Memorandum

Re: **Final MW-87 Area Investigation Work Plan Addendum
Defense Distribution Depot, Memphis Tennessee**

This *Draft MW-87 Area Investigation Work Plan Addendum Memorandum* was prepared by HDR, Inc. under Contract Number W91278-16-D-0061-W9127819F0090 to the United States Army Corps of Engineers (USACE), Mobile District. This Addendum notes changes from the *MW-87 Area Investigation Work Plan (Work Plan)* (HDR, 2020) for additional investigation to include sampling, analysis and evaluation of soil, soil vapor and groundwater on Dunn Field at the former Defense Depot Memphis, Tennessee (DDMT).

Figure 1

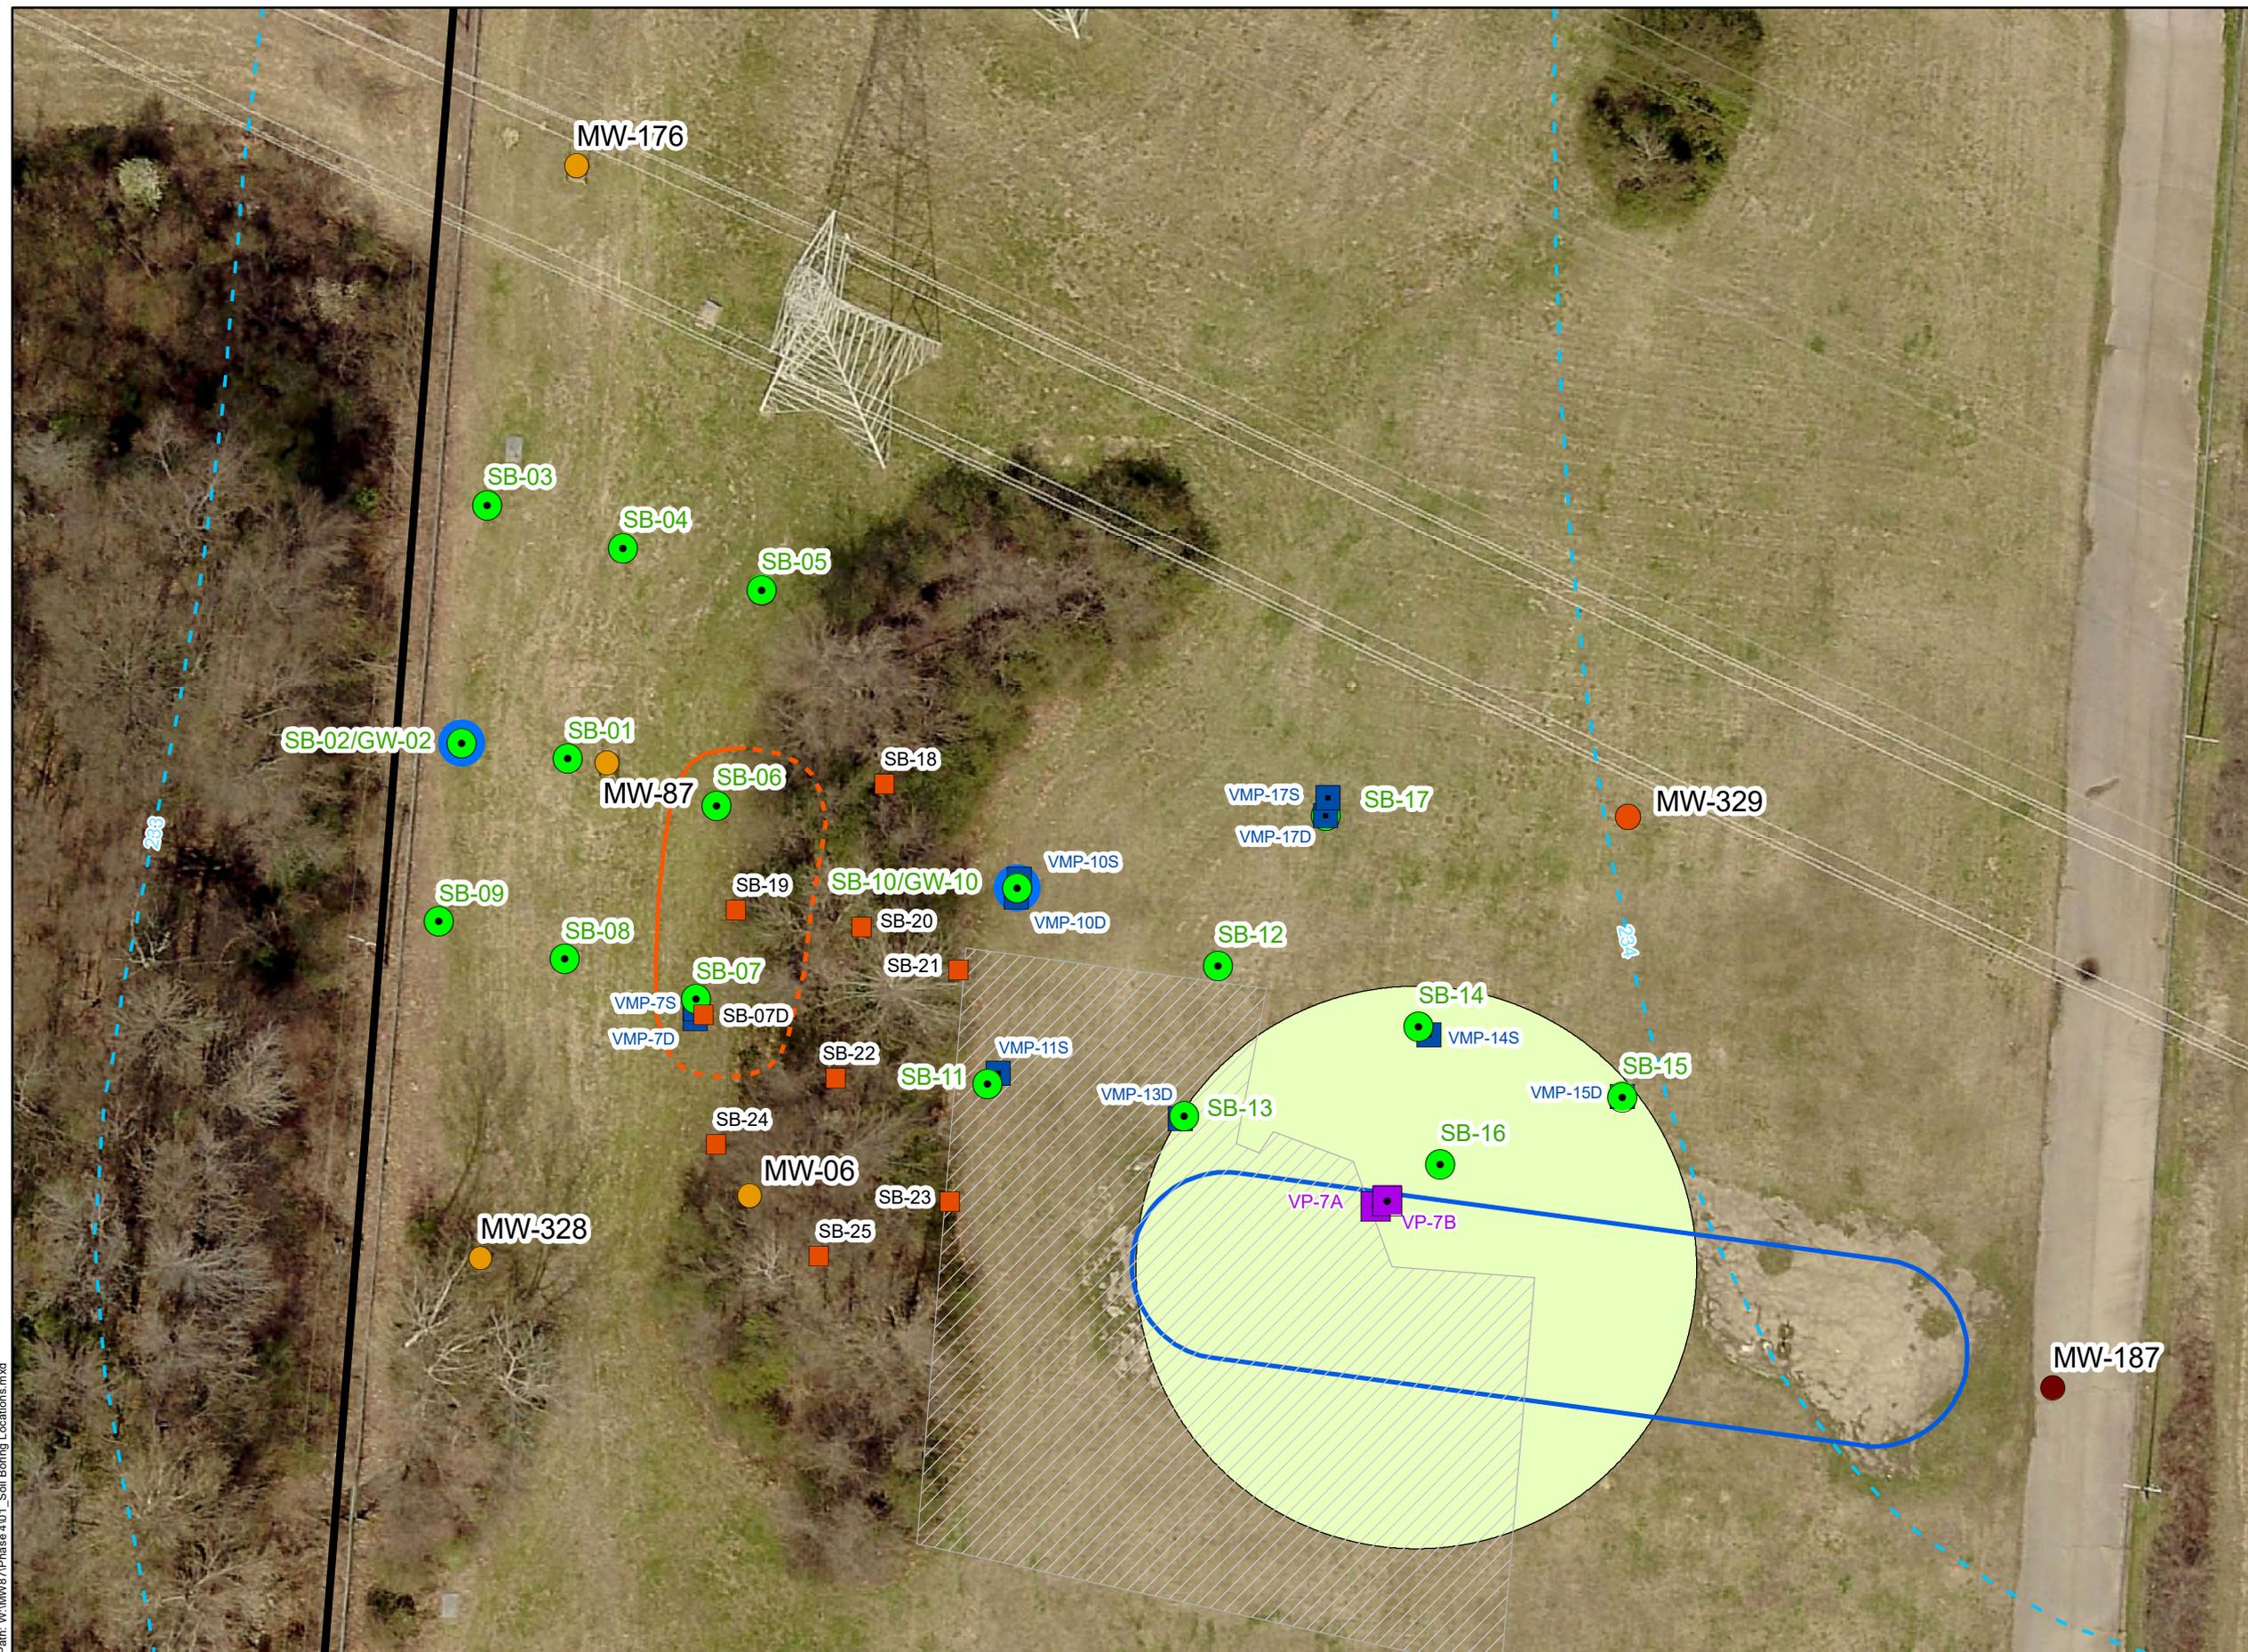
Locations for nine additional soil borings and the monitoring well are shown on [Figure 1](#). The location for a tenth soil boring will be determined based on photoionization detector (PID) measurements and observations at the nine borings, and locations for the additional VMPs will be determined based on the soil sample analytical results. The sampling, analysis and updated risk calculations will be presented in an addendum to the February 2021 MW-87 Area report.

Ten soil borings are planned; eight new boring locations and a boring for additional sampling adjacent to SB-07 are shown on [Figure 1](#). The tenth boring location will be selected based on PID measurements for samples collected at the other locations.

Monitoring well MW-329 will be installed upgradient of GW-10 at the location shown on [Figure 1](#). The well may be moved several feet to the south for the drill rig to be the necessary distance (20 ft) from the overhead power transmission lines. The surface elevation at the planned location is approximately 300 ft, NAVD (North American Vertical Datum of 1988); the April 2021 groundwater elevation at the location is approximately 235 ft NAVD, and the depth to water is approximately 65 ft below ground surface. The drilling, well construction, development and sampling will be as described in the Work Plan.
